Revised Range Clutch/Synchronizer
Components

T200, T300

FSB 431-003, Range Clutch Synchronizer Components

(July 2011)

W4065554

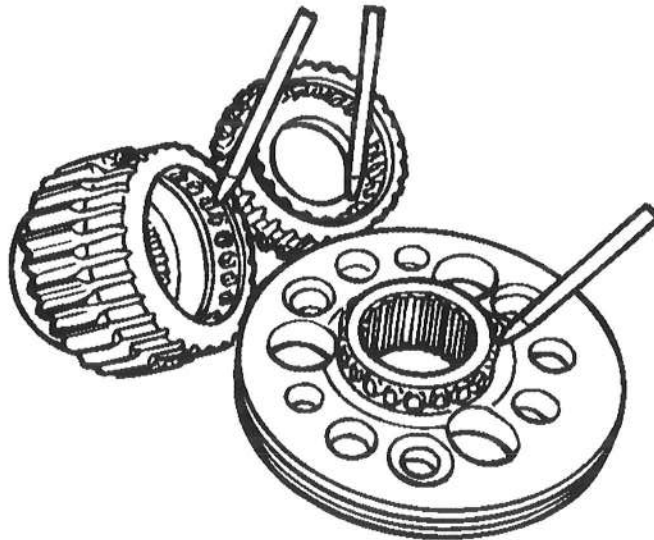
The T200/T300 range synchronizer clutch material and tooth design have been changed to improve durability and resist disengagement. A more robust material is now used. Also there is an increase in the dove-tail cut of the clutching teeth in both the synchronizer clutch and mating hi range gear and lo range hub. The new range synchronizer clutch and mating gears were incorporated into production on 05/23/2011, beginning with transmission serial number 3772. The part number for the new range synchronizer clutch is 21636360.

Clutch Teeth with Dove-tail Cut

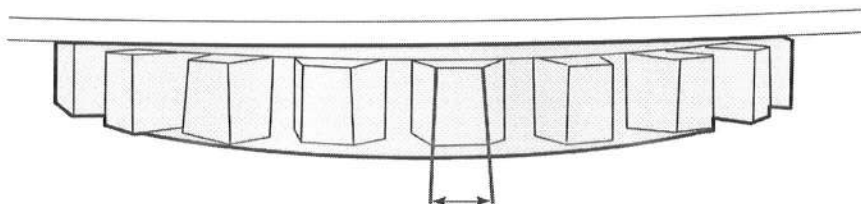
Because of the increase in the dove-tail cut of the clutch teeth between the previous style range clutch and the current production range clutch, the range clutch, the mating high gear and the low gear hubs must be replaced as a set. If any one of the three previous style components is damaged, or when converting from the previous style to the new style range clutch/synchronizer, all three items must be replaced with the current components. For replacement information for these components refer to the appropriate transmission model's service manual or Service Manual "In-Chassis Synchronizer Removal Manual", 10-701.
